To: Montgomery County Planning Board

From: Sarah Morse, Executive Director, Little Falls Watershed Alliance

Date: March 8, 2019

Re: Regency Centers/Equity One Development, Preliminary Plan 120170170; Site Plan 820180190

Figure 2. Above left : Pervious pavement used for parking spot. Above right: Water flows through the permeable pavement where it is infiltrated into the substrate.

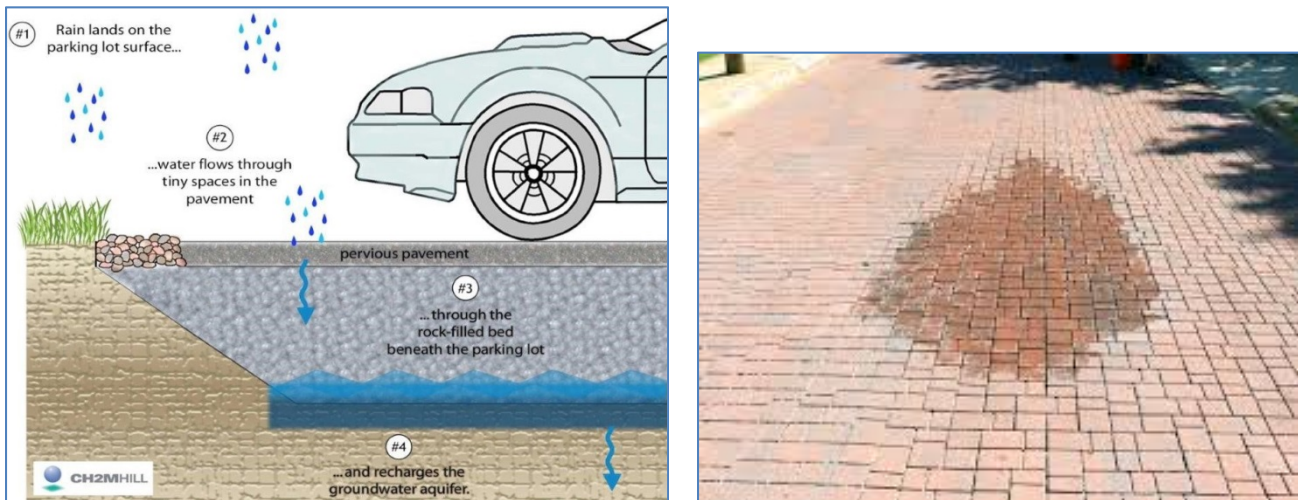
We support the DPS request that the applicant continue to look for ways to incorporate more permeable pavement. Permeable pavement is a type of pavement with a high porosity that allows rainwater to pass through it into the ground below. It can be used for sidewalks, driveways, parking lots, residential roads and more. (See Figure 2.) We recommend that the developer be directed to explore using it for sidewalks as well as in the loading dock and surface parking areas. Any time that run-off from a parking surface can be infiltrated, it is a win for the environment as pollution from cars is some of the worst. The applicant should have regular meetings with DPS so they can monitor how much progress is being made towards finding new places

Figure 3. Above left: Swale on the edge of a parking lot. Right: Swale with native plants captures the stormwater run-off and infiltrates it.

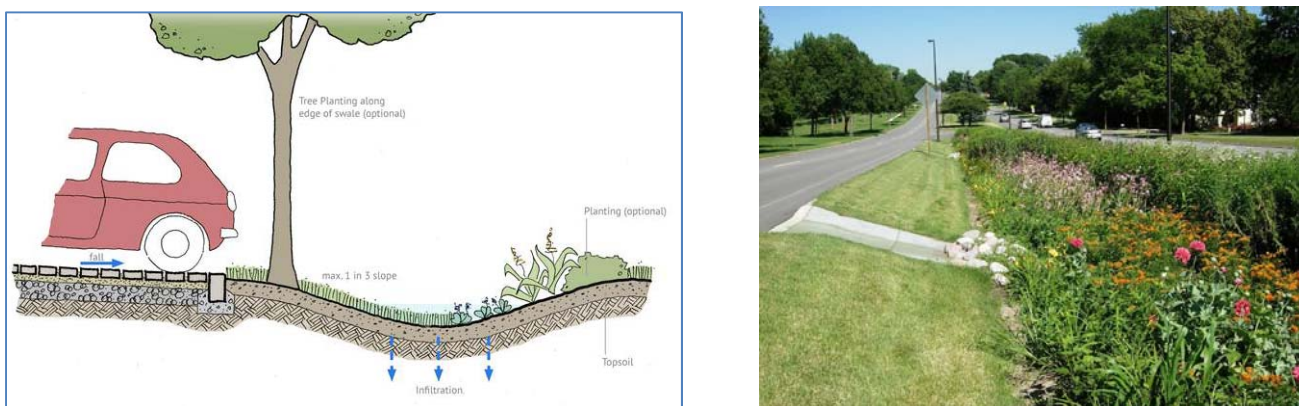
A buffer strip between Kenwood Place Condos (KPC) and the new townhouses is mandated in the Sector Plan (pg. 76) to “address the unmitigated storm flows.” We support the staff’s recommended conditions for a swale in this location that would “enhance the landscaping along the site boundary to increase infiltration” (pg. 15 Staff Report) with the emphasis on *infiltration*. (See Figure 3.) This buffer strip should function as green infrastructure and should be designed to allow the stormwater to soak into the ground through infiltration or by directing 100% of the flow to the rain gardens. Check dams should slow the run-off and the swale should be planted with native plants which provide increased infiltration. Anything less would allow untreated water from the Kenwood parking lots and roads to flow to the new creek – bringing with it the mix of chemical and trash pollution that is urban stormwater run-off.

Access to the Park:

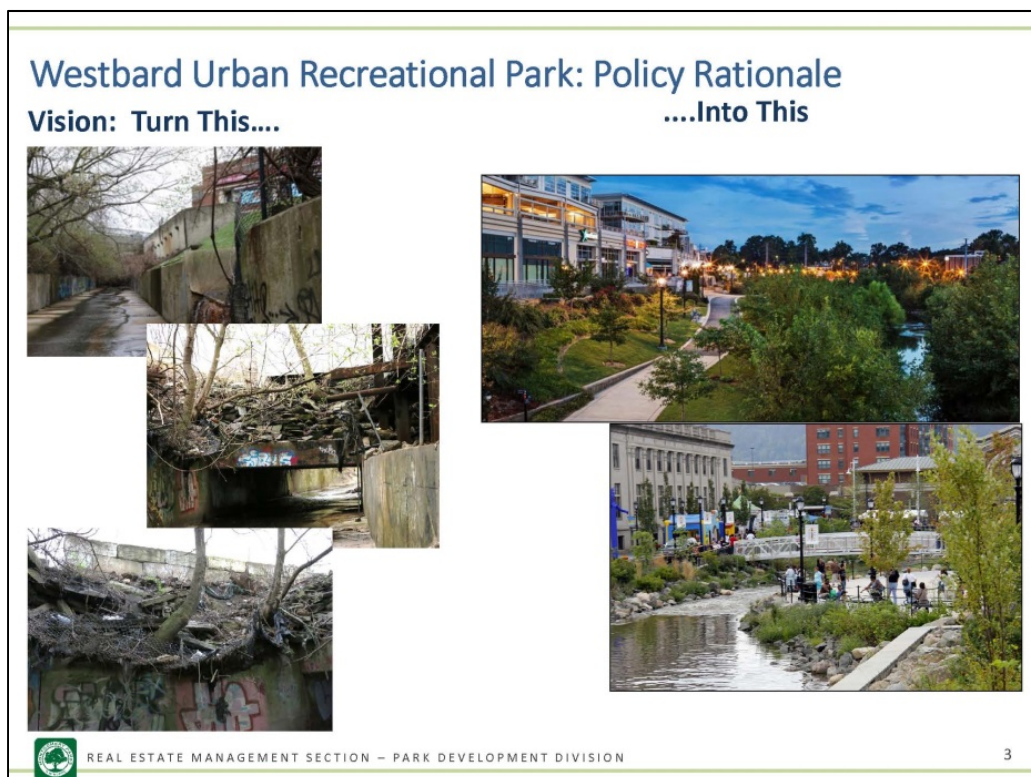
The Sector Plan calls for an access to the greenway park from Westbard Avenue across Parking Lot 1. This should be indicated on the certified preliminary plan.

AFTER: Regency Centers Development with Enhanced ESD Proposed by Little Falls Watershed Alliance

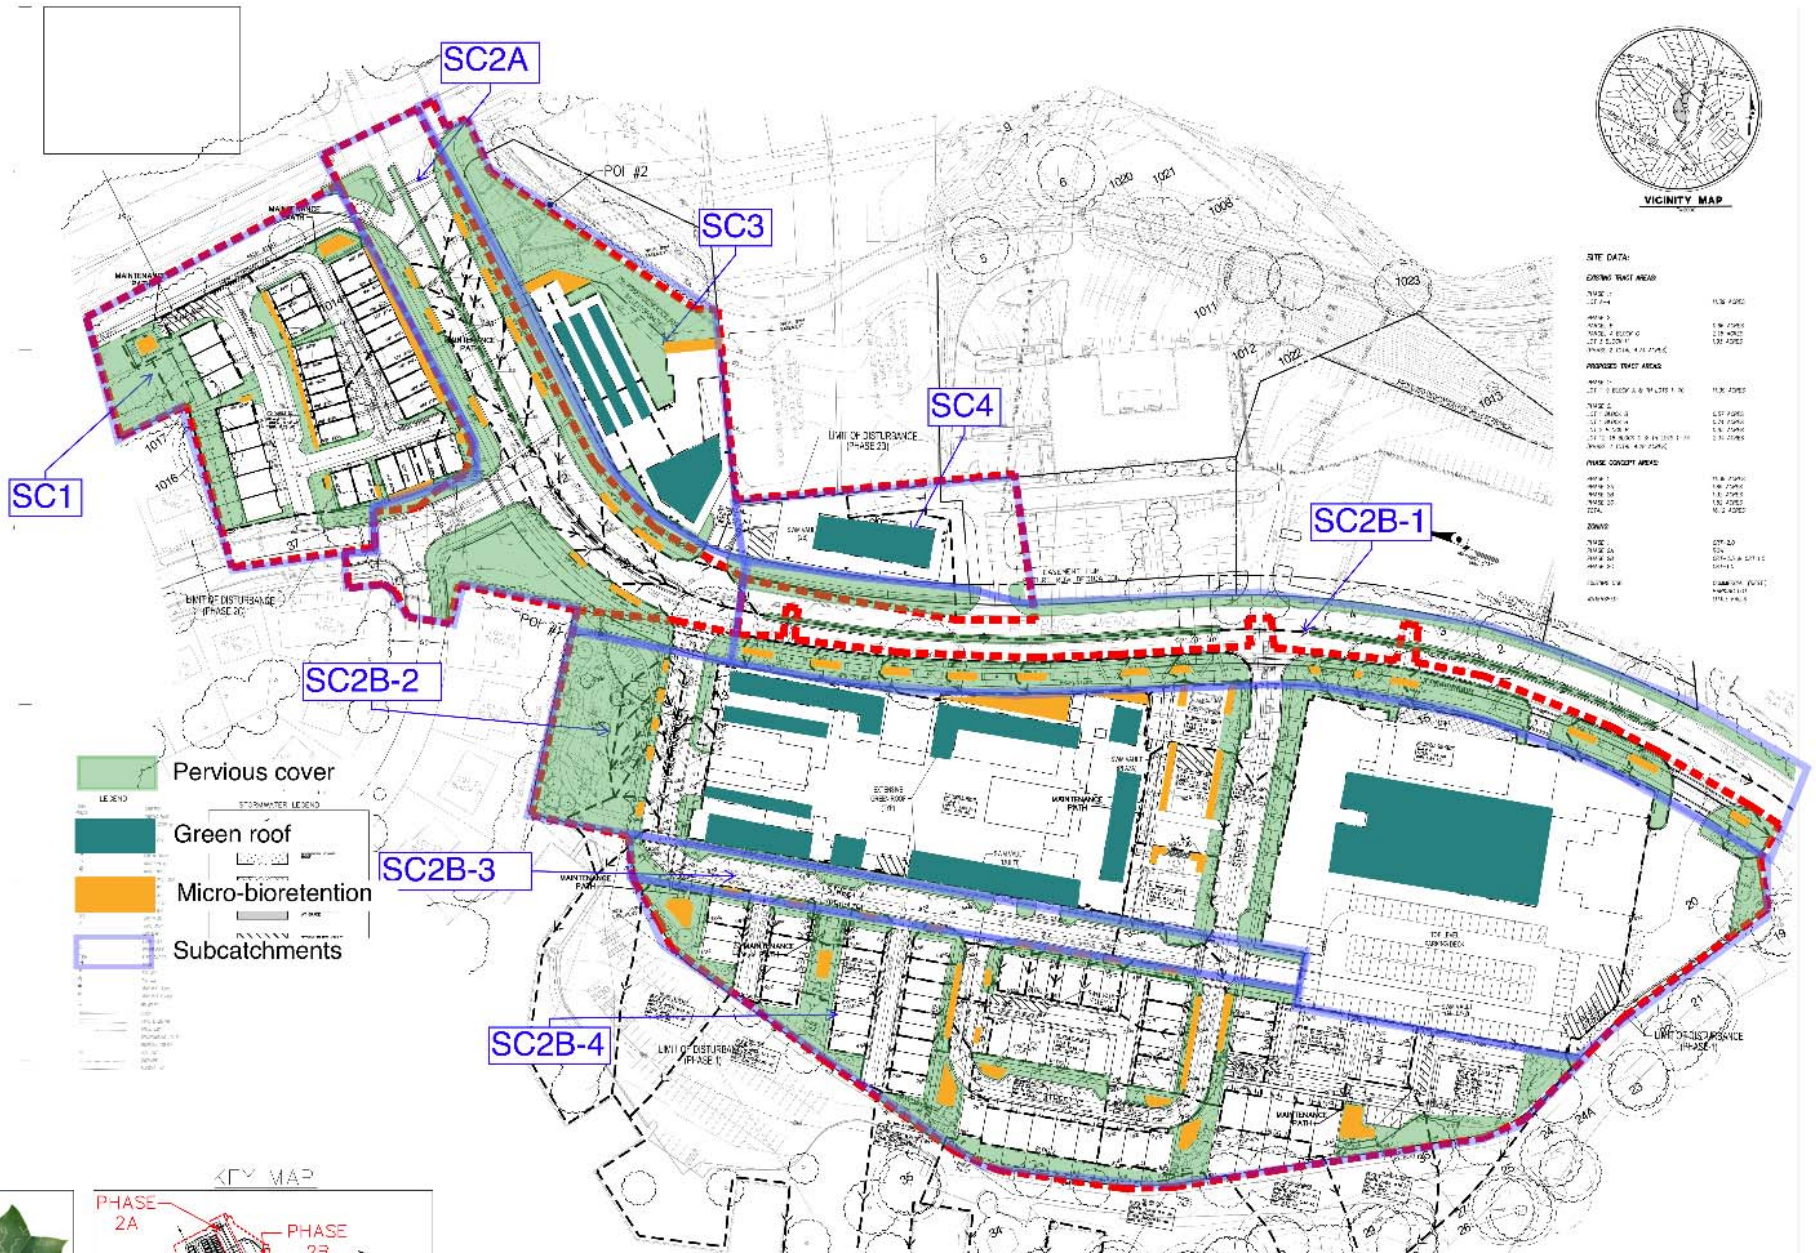
100% Environmental Site Design and NO fee-in-lieu waiver means that most of the stormwater soaks into the ground where it is cleaned by the bacteria living in the soil, recharges the groundwater, and improves the baseflow of the Willett Branch.

Less than 50% Environmental Site Design and a 11% fee-in-lieu waiver means that most of the stormwater does not soak into the ground. Instead, it flows directly to the Willett Branch where it causes flooding, erosion, and polluted waters.
